Pope Lick Station

14ZONE1064

14005 Taylorsville Road

Why We are Opposed to this Project

Why We are Opposed to this Project

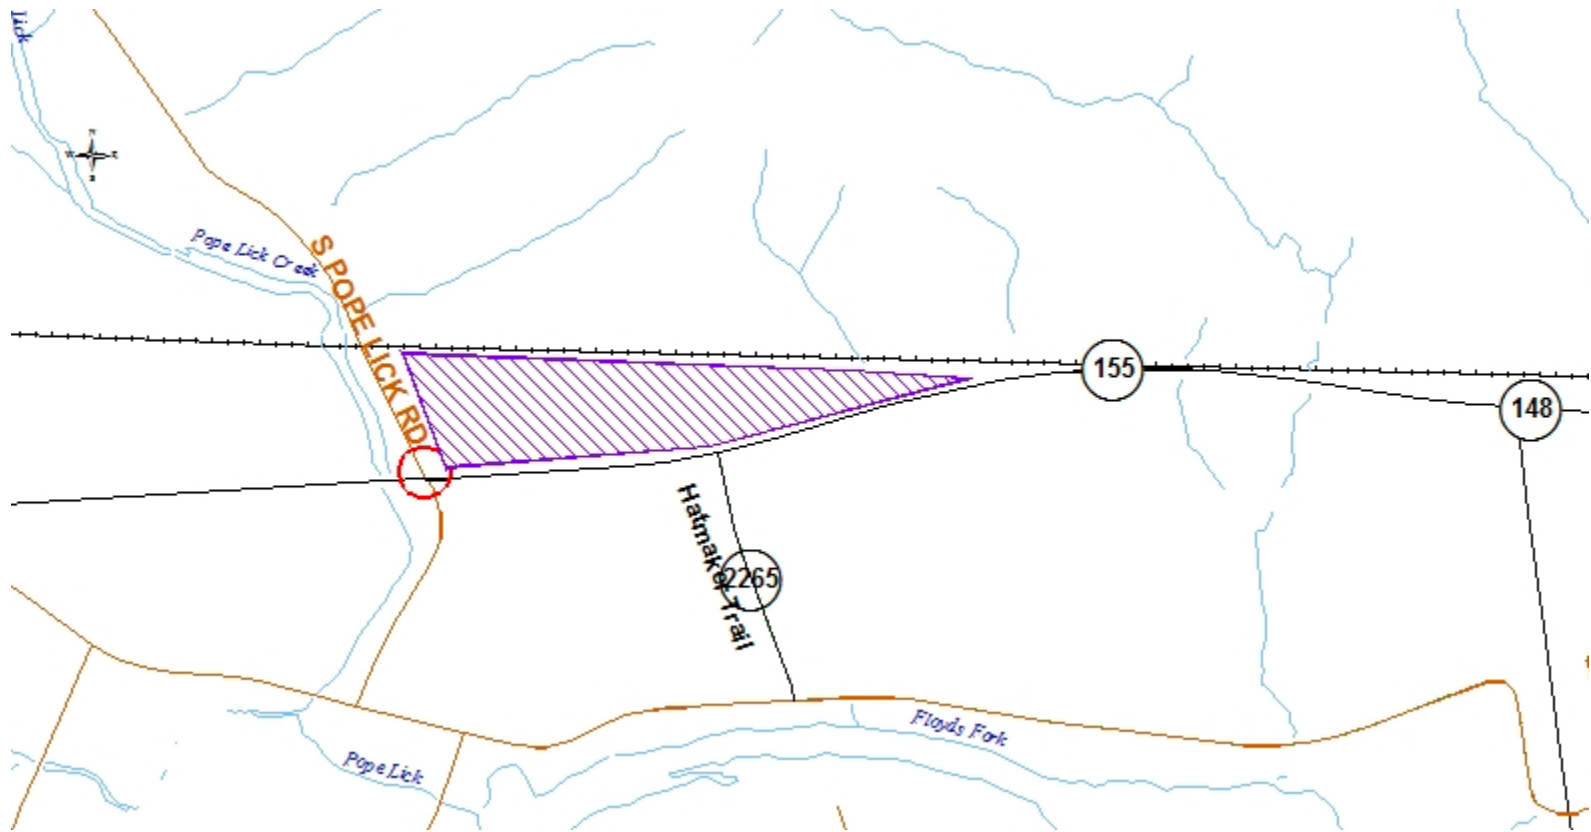
- The applicant is proposing to clear cut all of the existing tree cover and has not retained or provided for the minimum required tree cover of 25%.
 - The applicant has not detailed existing tree cover, stating that it is “about 50%”; our review indicates the cover is far more extensive.
 - A tree protection plan has not been filed.
- To our knowledge no other property in the Floyds Fork DRO has successfully obtained a commercial rezoning from RR zoning since 1993 – this is not the place to start!

Retaining Walls Adjacent to Railroad

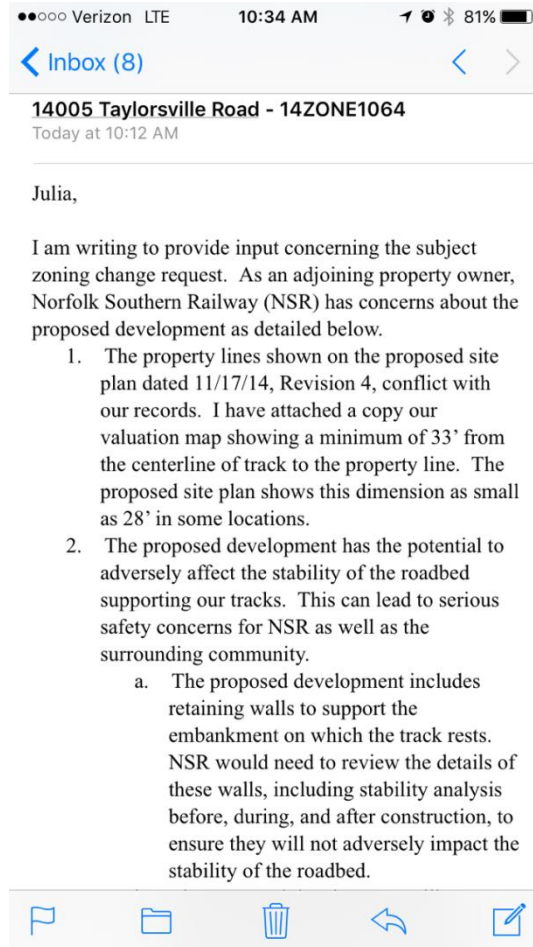
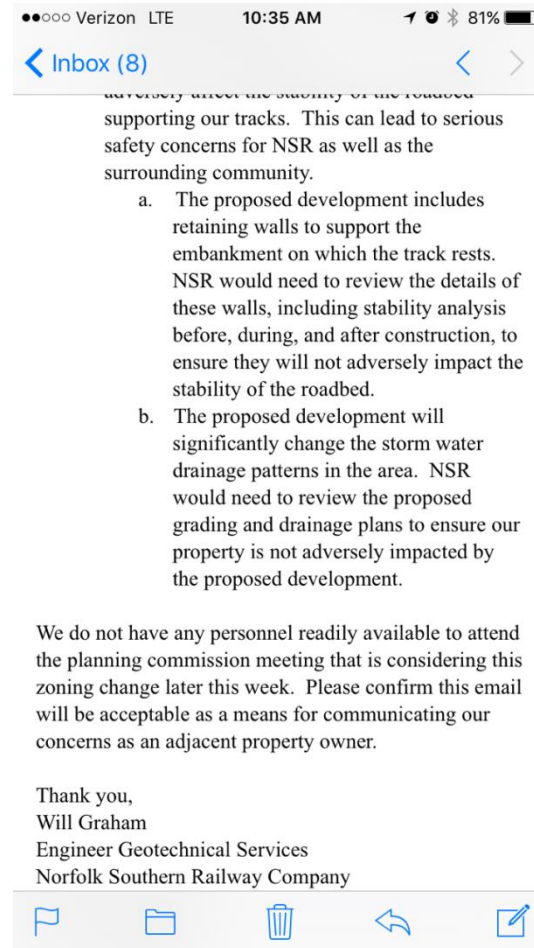
- “The proposed development has the potential to adversely affect the stability of the roadbed supporting our tracks. This can lead to serious safety concerns for NSR and the surrounding community.”
- NSR has additional right of way and drainage concerns
- Calling for stability analyses “before, during, and after construction.”

Pope Lick Road Section

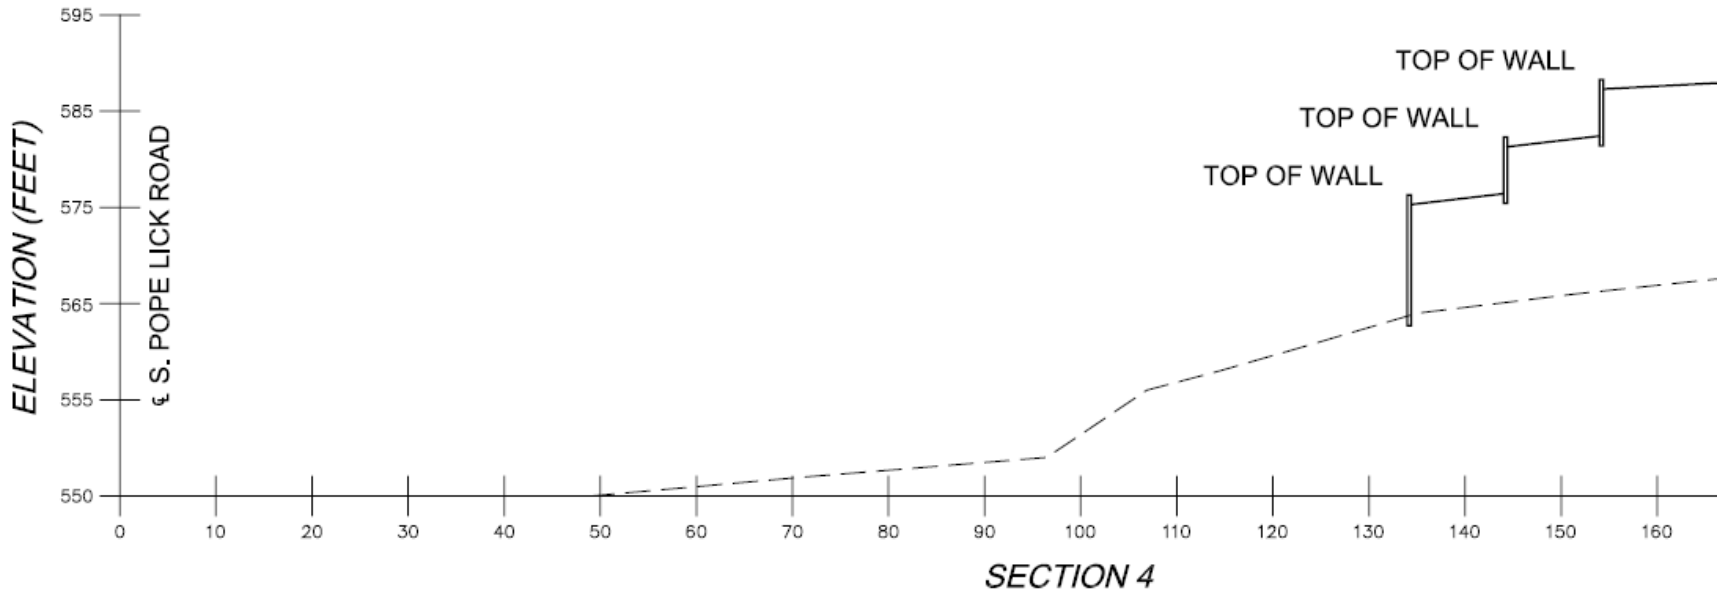
- This project is placed on a prominent hillside in the middle of the RR zoned DRO, visible from the Louisville Loop, Pope Lick Park, and has significant viewshed impacts:
 - Fronts on Taylorsville Road which is a scenic corridor
 - Proposes to clear cut existing hillside, removing visual and sound screen to the railroad that is now provided by existing vegetation
